CITY OF ALBUQUERQUE

**RE: 6208 Whiteman Dr NW
Grading and Drainage Plan
Engineer's Stamp Date: 04/02/24
Hydrology File: E10D127**

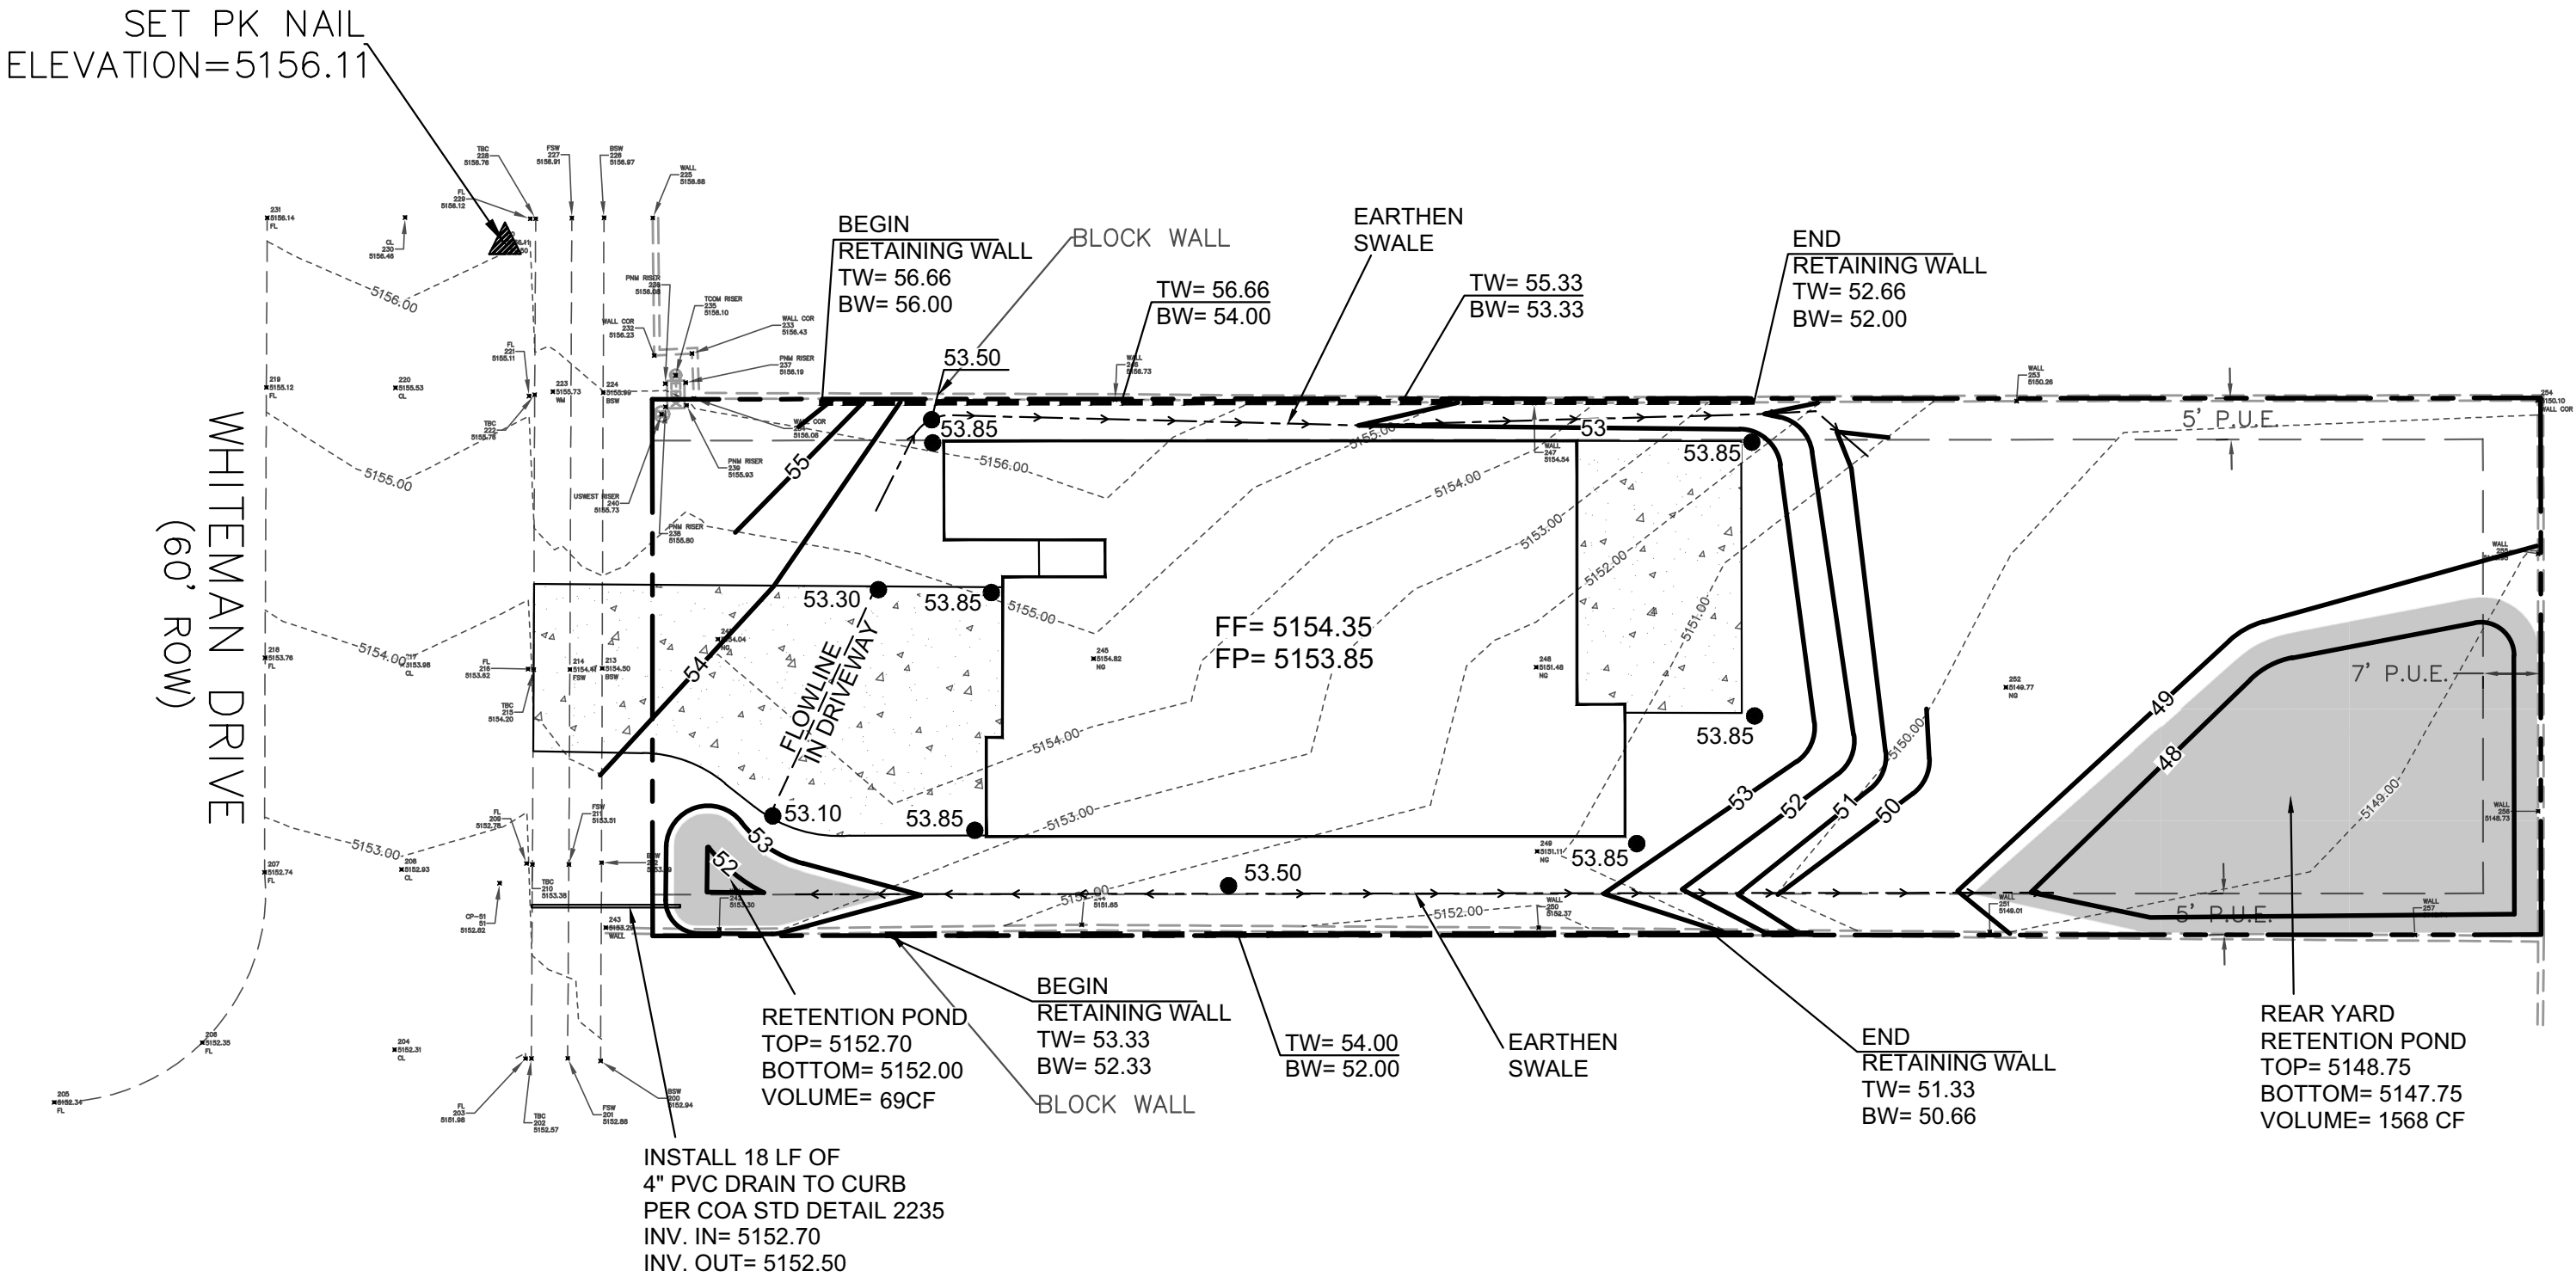
Based upon the information provided in your submittal received 04/03/2024, the Grading and Drainage Plan is approved for Building Permit and Grading Permit. **Since this site is relatively flat and grades slightly to the rear, a pad certification is not needed for this project.** Please attach a copy of this approved plan in the construction sets for Building Permit processing along with a copy of this letter.
